SUBJECT: BELLEFONTE NUCLEAR PLANT, UNITS 1 AND 2 - STAFF ASSESSMENT OF INFORMATION PROVIDED PURSUANT TO TITLE 10 OF THE CODE OF FEDERAL REGULATIONS PART 50, SECTION 50.54(f), SEISMIC HAZARD REEVALUATIONS FOR RECOMMENDATION 2.1 OF THE NEAR-TERM TASK FORCE REVIEW OF INSIGHTS FROM THE FUKUSHIMA DAI-ICHI ACCIDENT (TAC NOS. MF3944 AND MF3945)

STAFF ASSESSMENT BY THE OFFICE OF NUCLEAR REACTOR REGULATION

RELATED TO SEISMIC HAZARD AND SCREENING REPORT

BELLEFONTE NUCLEAR PLANT, UNITS. 1 AND 2

Figure 3.2-1 Plot comparing the Staff's and the Licensee's Mean Control Point Hazard Curves at a Variety of Frequencies for the Bellefonte Site

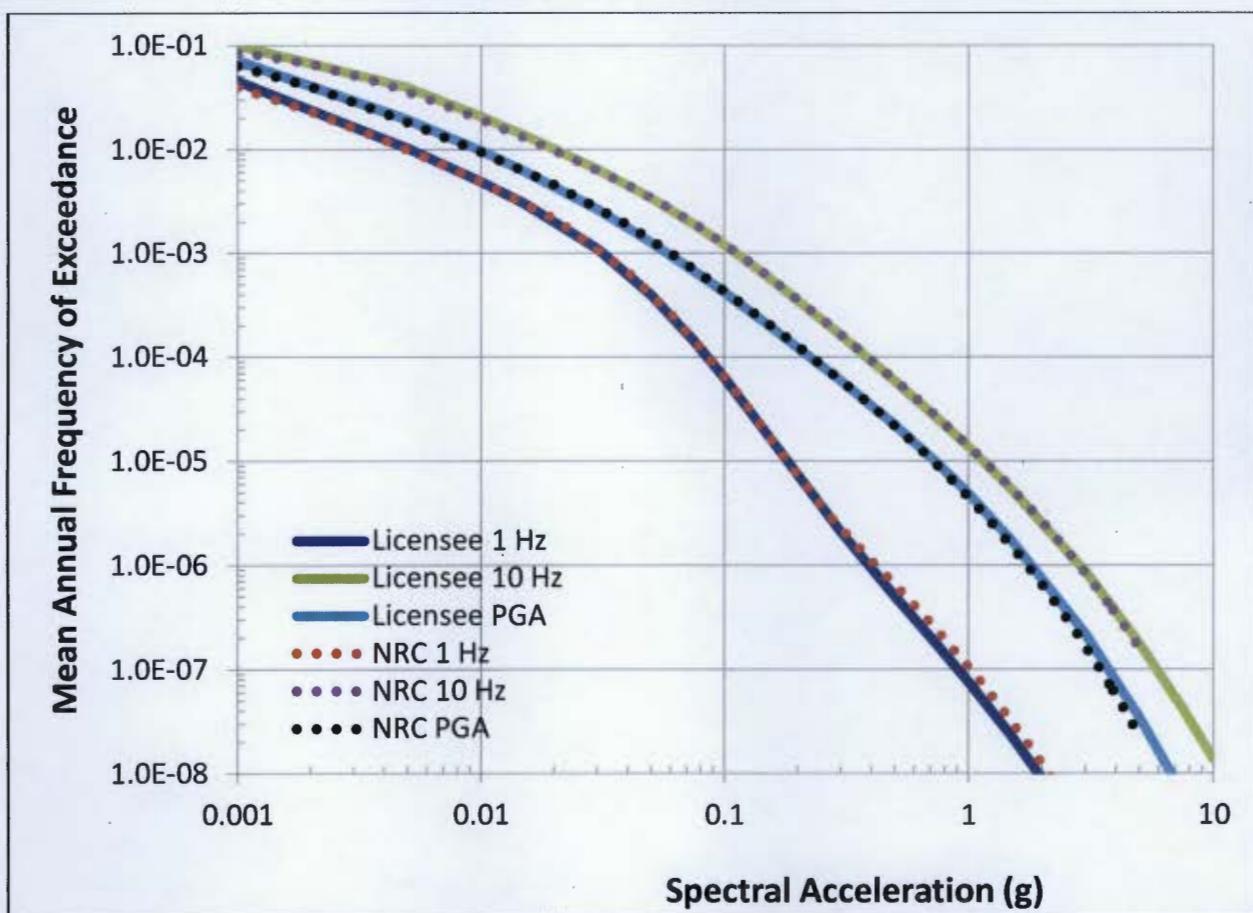
used the mid-continent version of the updated EPRI GMM (EPRI, 2013), except for the Extended Continental Crust-Gulf Coast (ECC GC) background seismic source. For the ECC GC source zone, the staff used the Gulf Coast version of the updated EPRI GMM (EPRI, 2013). Figure 3.2-1 of this assessment shows the hazard curves developed by the licensee and those developed by the staff using the CEUS-SSC at three of the seven spectral frequencies. As expected, the hazard curves developed by the licensee and the staff are similar at all frequencies.

Based on its review of the SHSR and the licensee's RAI response, the NRC staff concludes that the licensee appropriately followed guidance provided in the SPID for selecting the PSHA input models and parameters for the site. This includes the licensee's use and implementation of the CEUS-SSC model and the updated EPRI GMM.

Figure 3.4-1 Comparison of the Staff's GMRS with Licensee's GMRS and the Bellefonte Units 1 and 2 SSE.

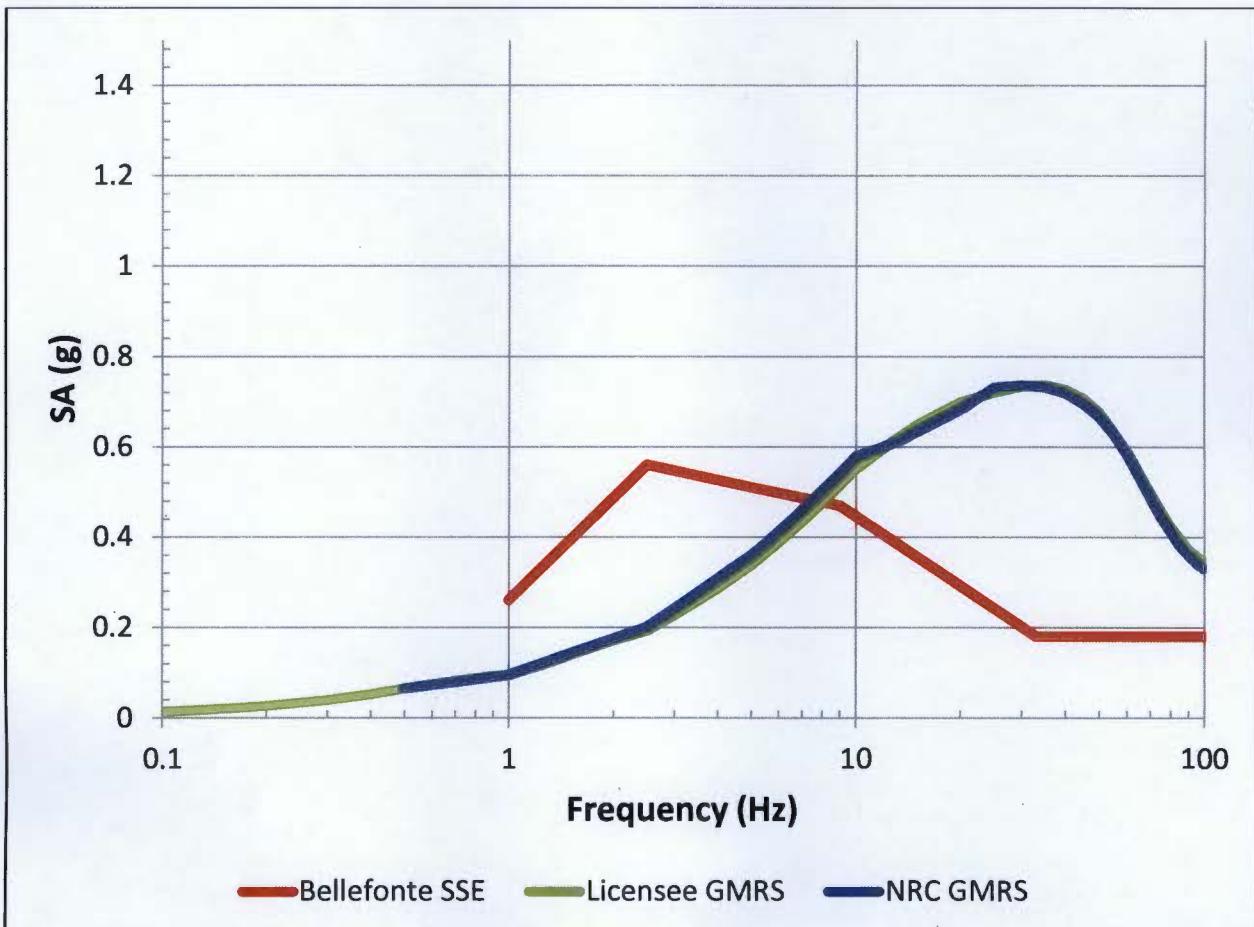
The NRC staff independently calculated the 10^{-4} and 10^{-5} UHRS using the results of its confirmatory PHSA, as described in Section 3.2 of this staff assessment. Figure 3.4-1 of this assessment shows a comparison of the GMRS determined by the licensee to that determined by the NRC staff. As shown in Figure 3.4-1 below, the licensee's GMRS shape and amplitude is nearly identical to that calculated by the NRC staff at all frequencies. The small differences that are present are attributed to differences in software used for hazard calculations.

The NRC staff confirms that the licensee used present-day guidance and methodology outline in RG 1.208 and the SPID to calculate the horizontal GMRS, as requested in the 50.54(f) letter. The NRC staff performed a confirmatory PSHA and achieved results consistent with the licensee's horizontal GMRS. As such, the staff concludes that the GMRS determined by the licensee adequately characterizes the reevaluated hazard for the Bellefonte site. Therefore, this GMRS is suitable for use in subsequent evaluations and confirmations, as needed, for the response to the 50.54(f) letter.
